ADDENDUM No. 2

RFP No. 25-06

Pittsfield Village Improvements

PHASING PLAN

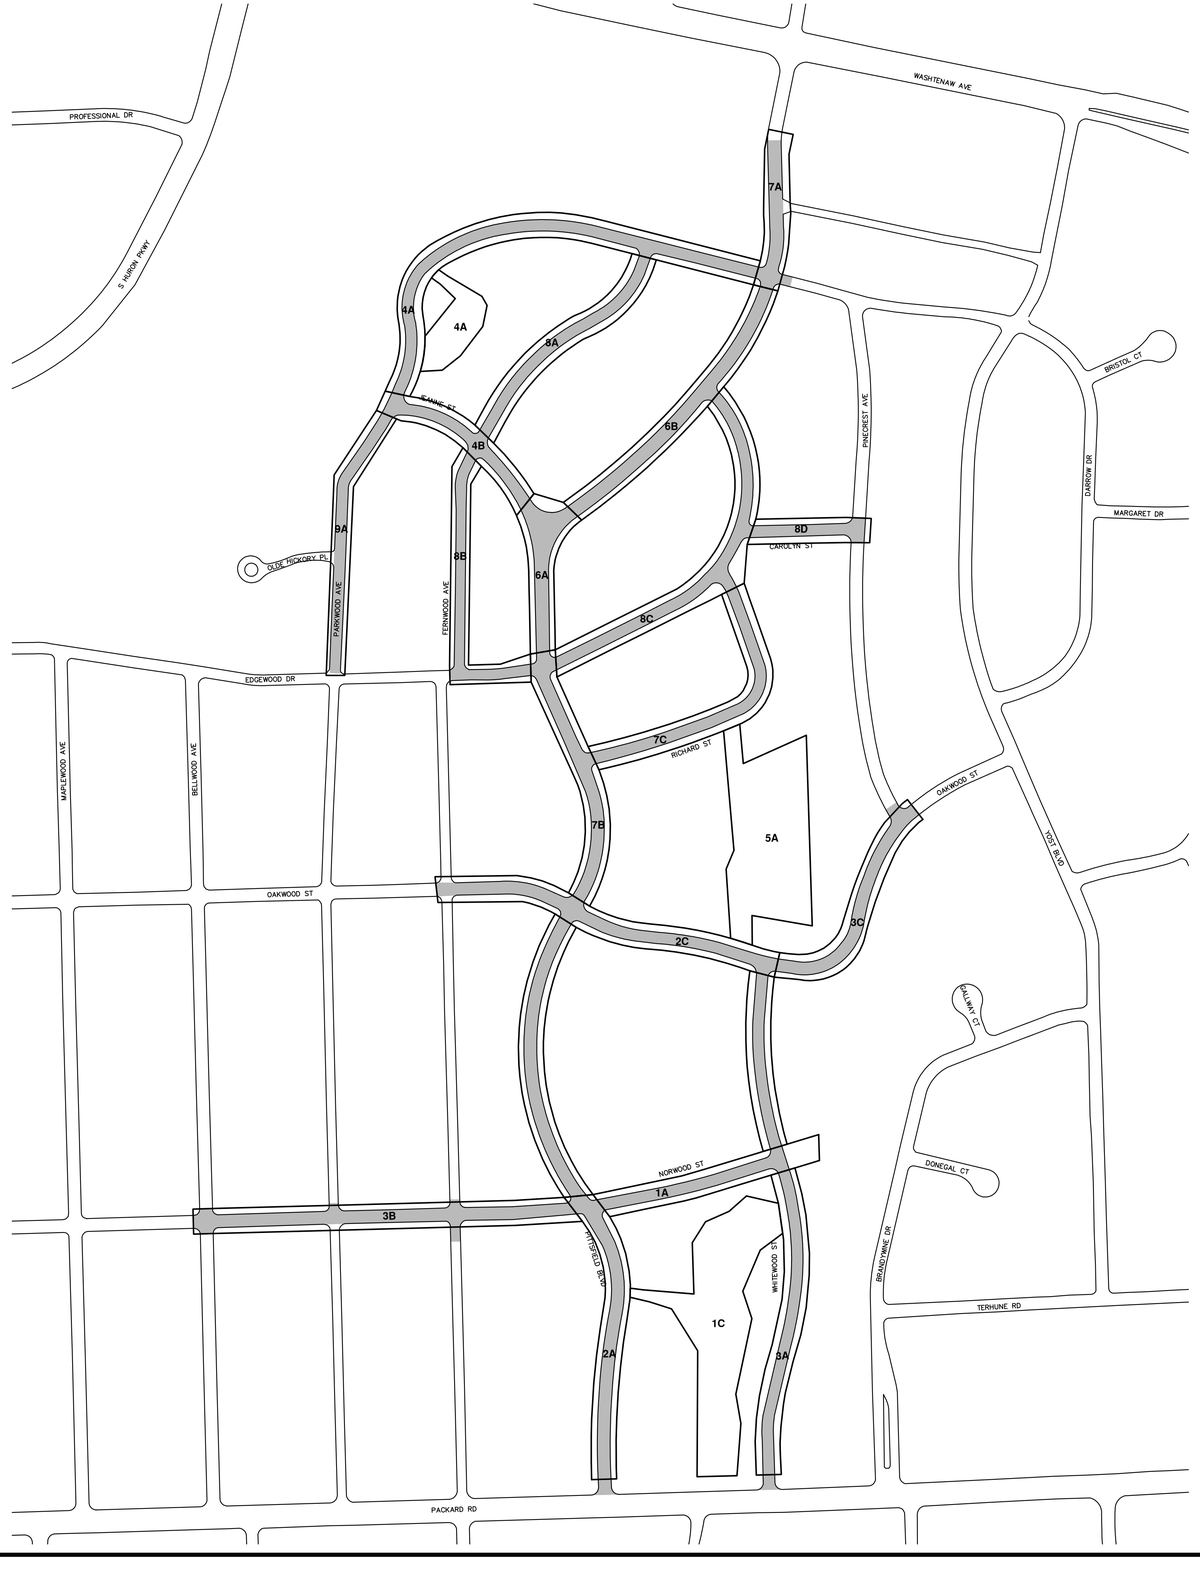
Question: *On Sheet 22 – Phasing: Is it the case that the Contractor can't start phase 1A until 1B is totally done?*
Response: The color phasing map will be included in the Addendum for easier review/understanding by the Proposers.

H17

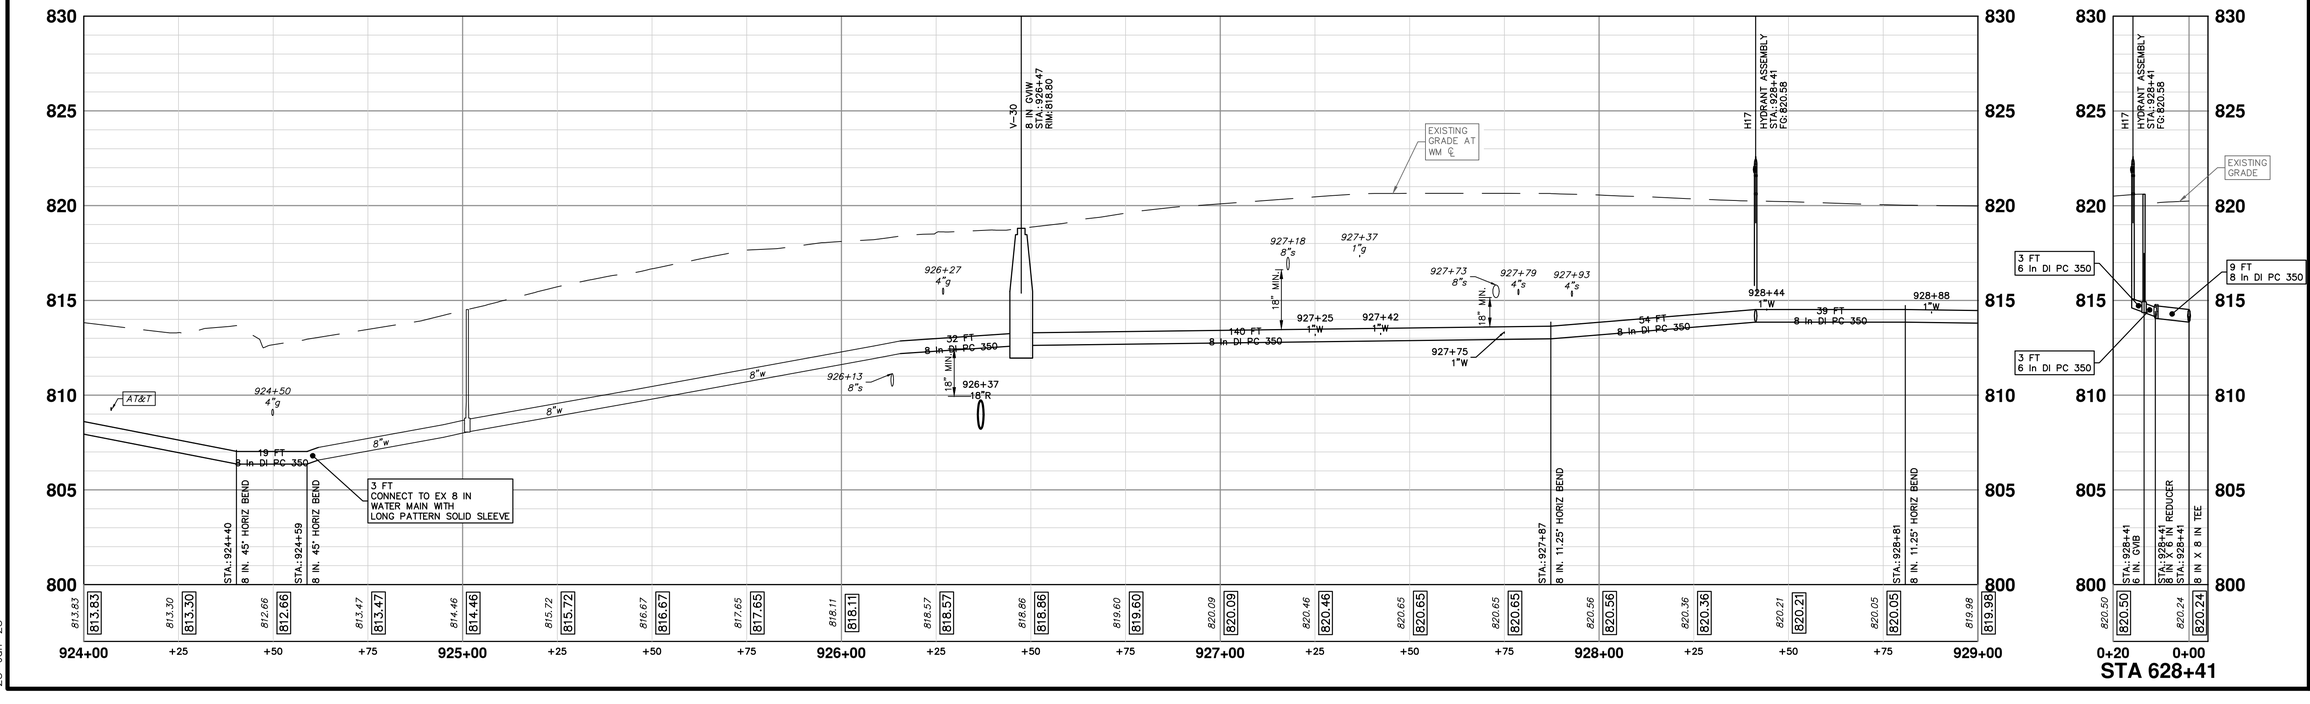
138	Minor quantity updates
141	Minor quantity updates
142	Minor quantity updates
143	Updated inverts, Inlet connection profile added
144	Updated inverts, Inlet connection profile added
Fernwood Avenue	
149	Minor quantity updates
150	Minor quantity updates
151	Added DD callout
152	Added DD callout and hydrant run profile H17
154	Added inlet connection profiles

SCHOOL DETENTION BASIN

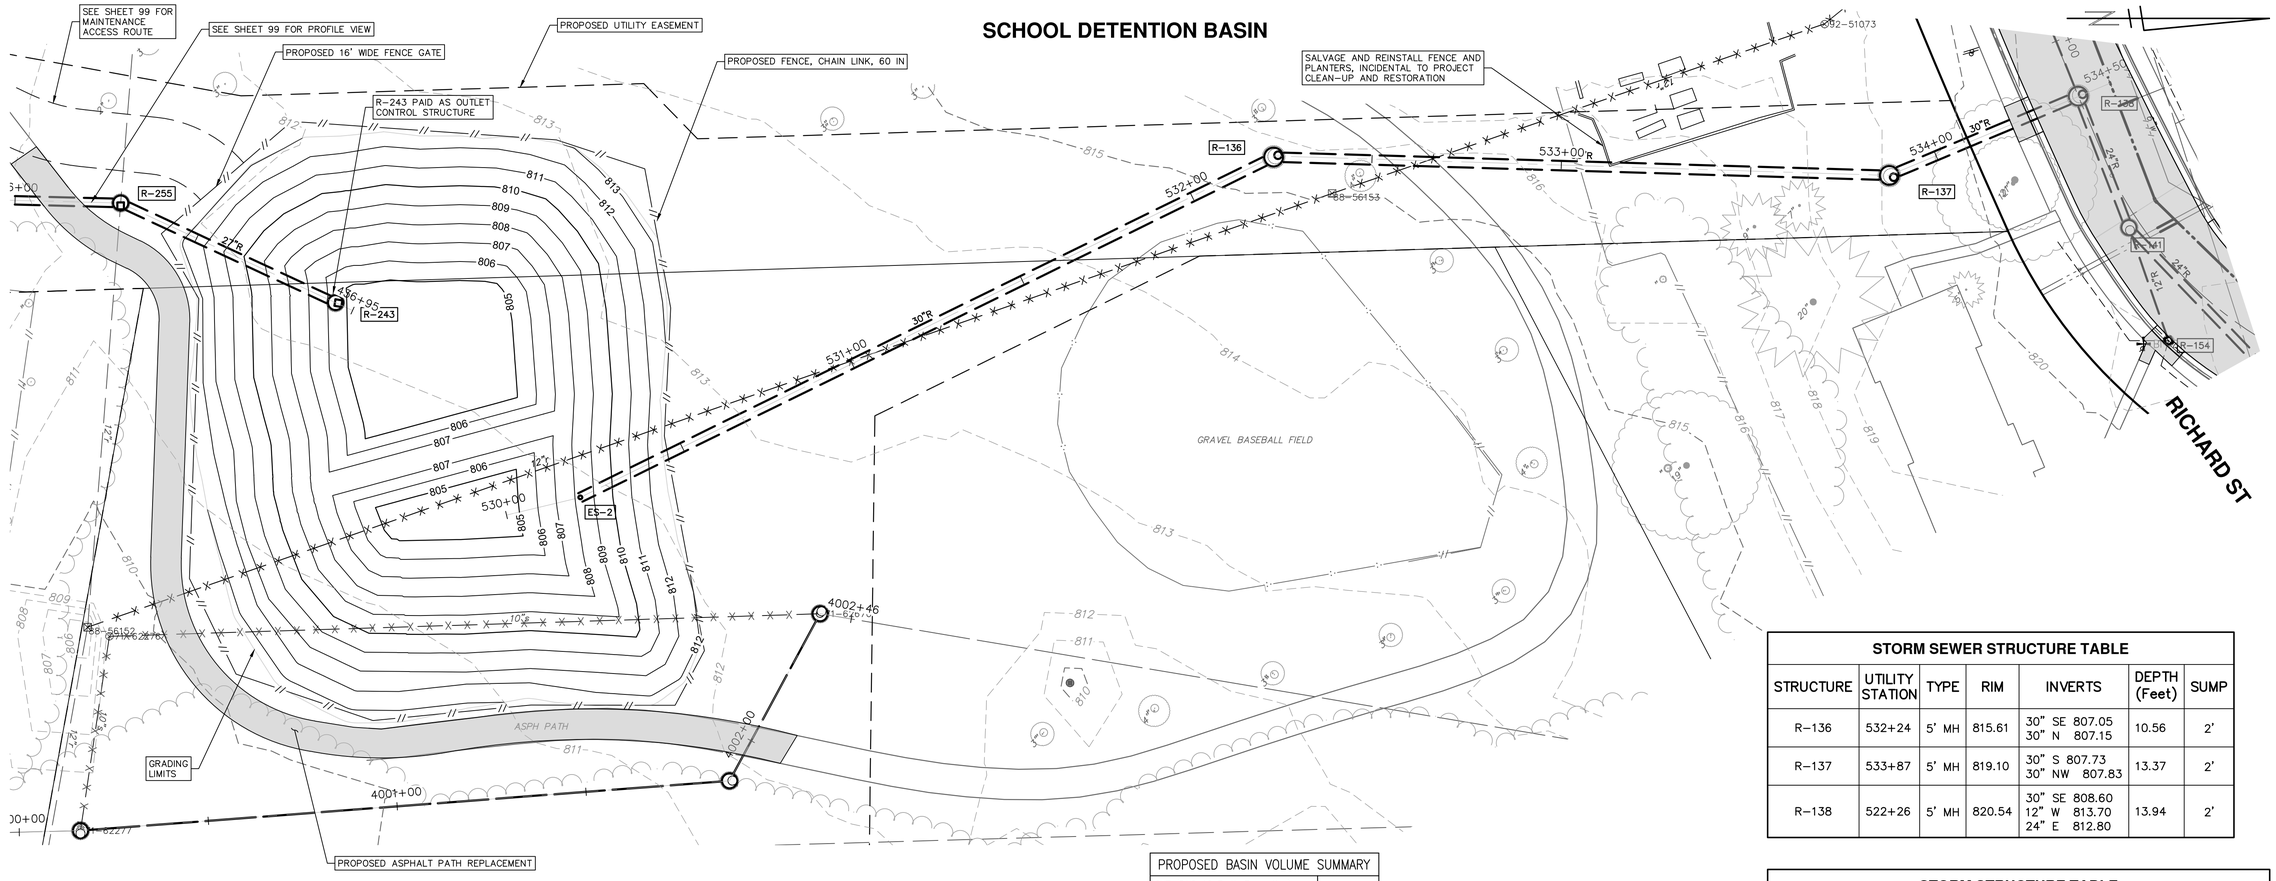
Detailed grading	
159	Updated asphalt path replacement
Standard Details	
162	Updated notes
167	Added Detour plan
Overall Updates	Updated at storm manholes to include a 2’ sump
